**FINDINGS AND RECOMMENDATION  
OFFICE OF PLANNING AND ZONING  
ANNE ARUNDEL COUNTY, MARYLAND**

**CASE NUMBER:** 2025-0224-V

The applicant is requesting variances to allow dwelling additions (garage, 2nd story) and accessory structures (deck, pavilion, spa) with less setbacks and buffer than required and with disturbance to slopes of 15% or greater on property located at 200 Glen Oban Drive in Arnold.

PROP. CONDITIONS SITE PLAN

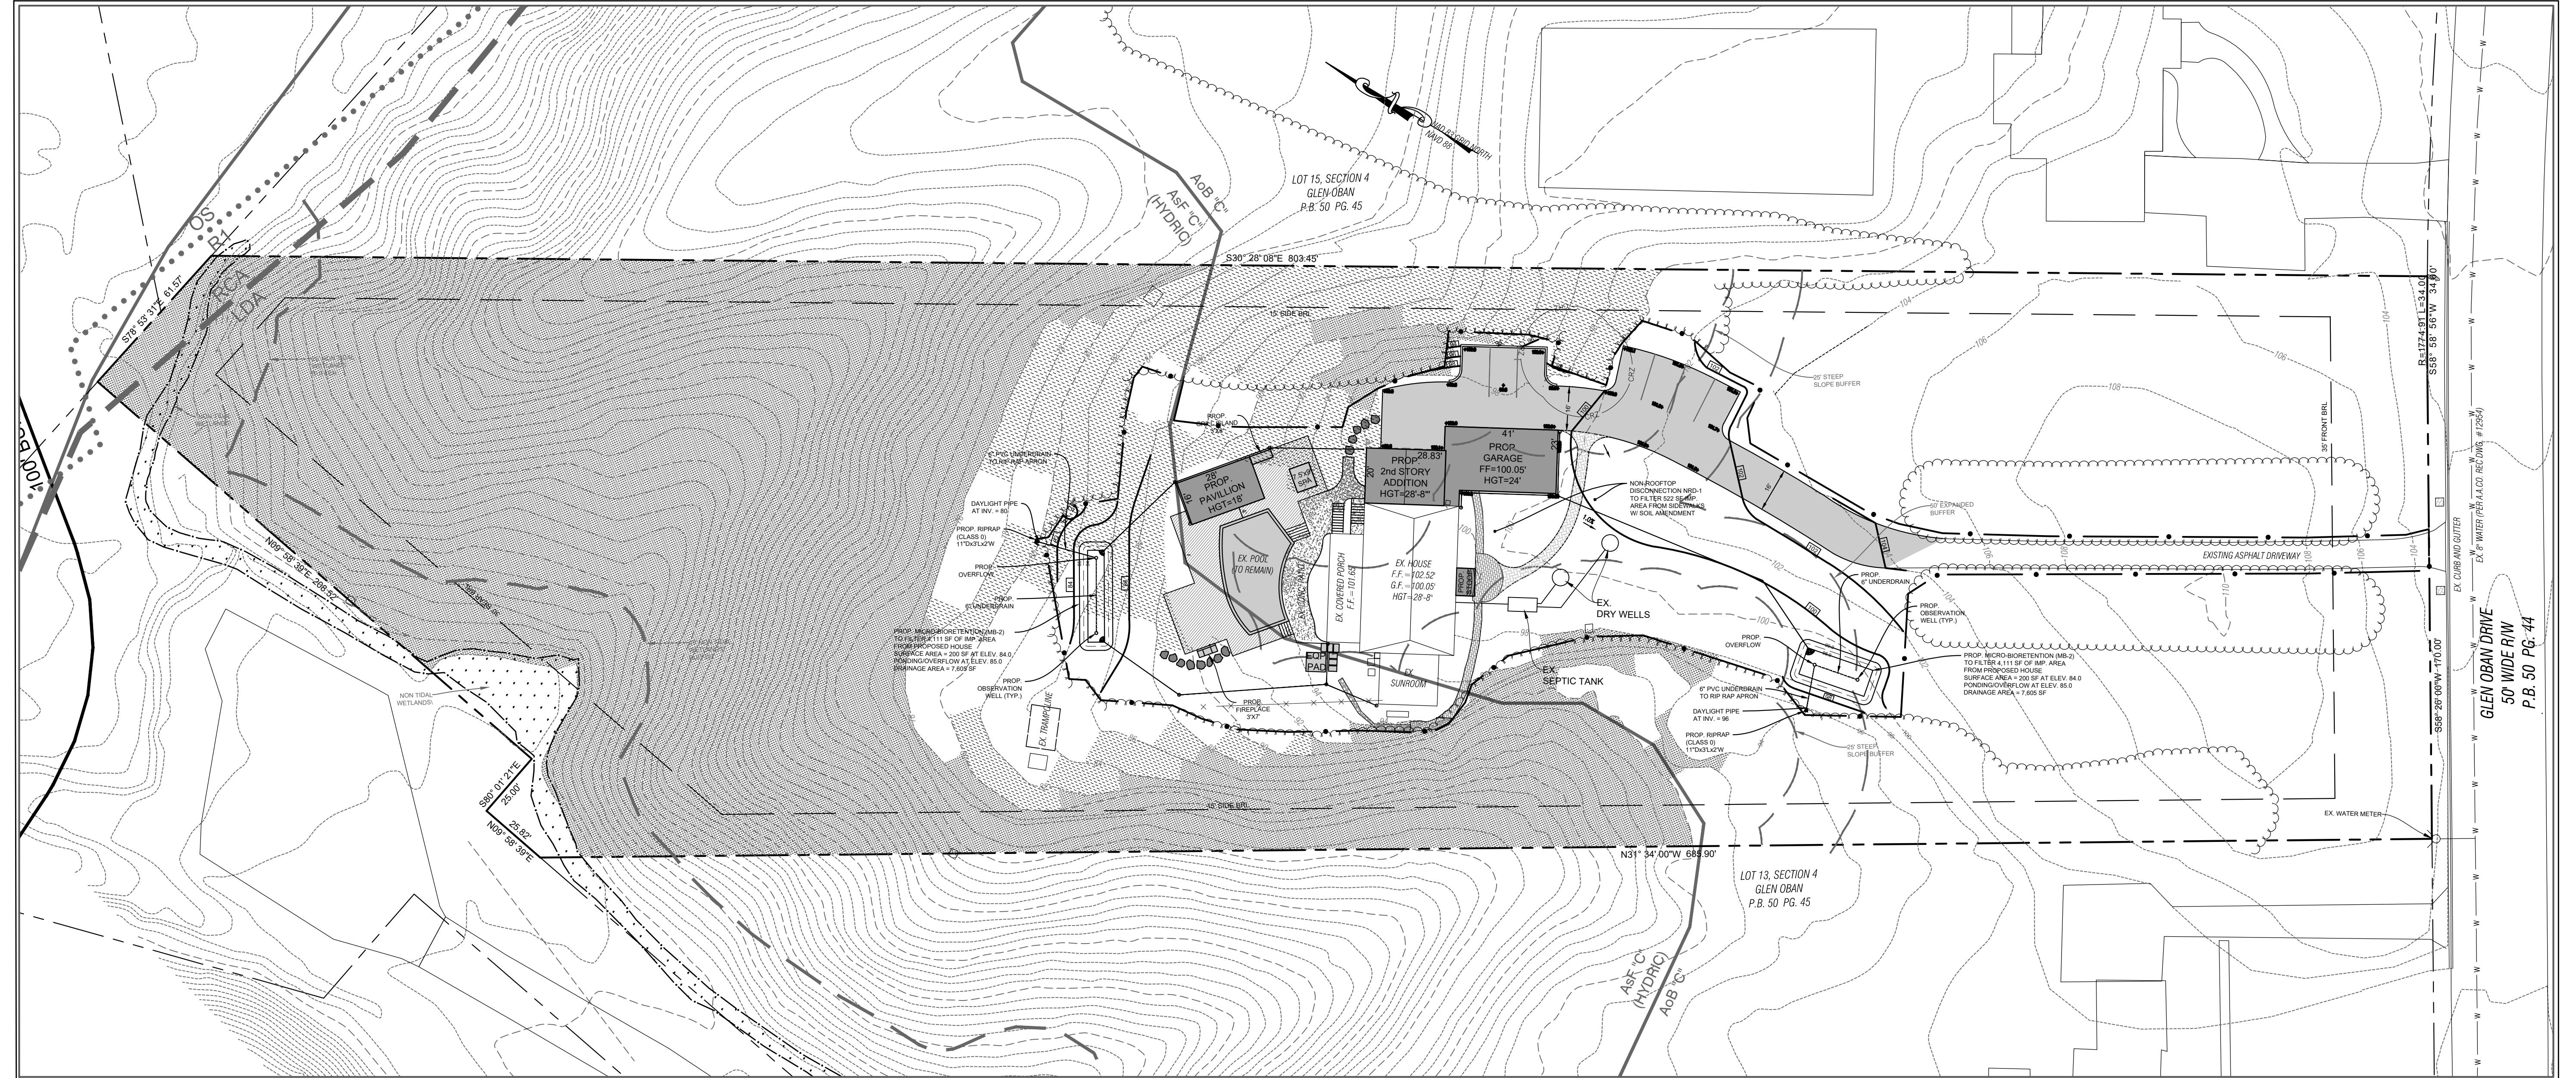
1. Move the rear MB-2 to the west to reduce disturbance in the steep slopes.
2. Show and label secondary and tertiary dry wells. SWM must meet setbacks to these dry wells.

This plan does not represent development standards appropriate for development within the Critical Area buffer nor do they meet the requirements for the approval of a variance in the Critical Area.
